24 November 2016

File Number: 2016/617649  
Our Ref: R/2016/26/A

**State Significant Development 16\_7881 – Sydney Opera House Building  
Renewal Program - Function Centre and Related Works**

**Figure 1:** 1973-c1989 showing tables and chairs and planters associated with the cafe

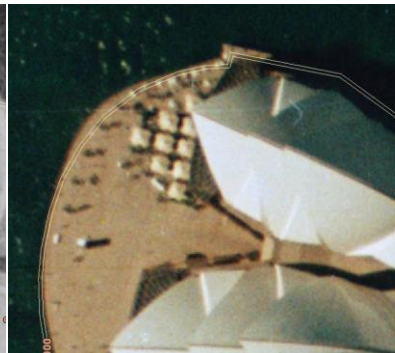
Below is a series of aerial images from 1973 to the present, which show how the outdoor eating area in the north-east corner of the 'broad walk' was activated for public outdoor seating between 1979 and 2003.

The above images demonstrate how the original design intent has been diminished over the years. This application presents an opportunity to re-establish the north-eastern corner of the 'broad walk' for general public access and for free public use as an outdoor seating area. The City would be highly supportive of such a proposal.
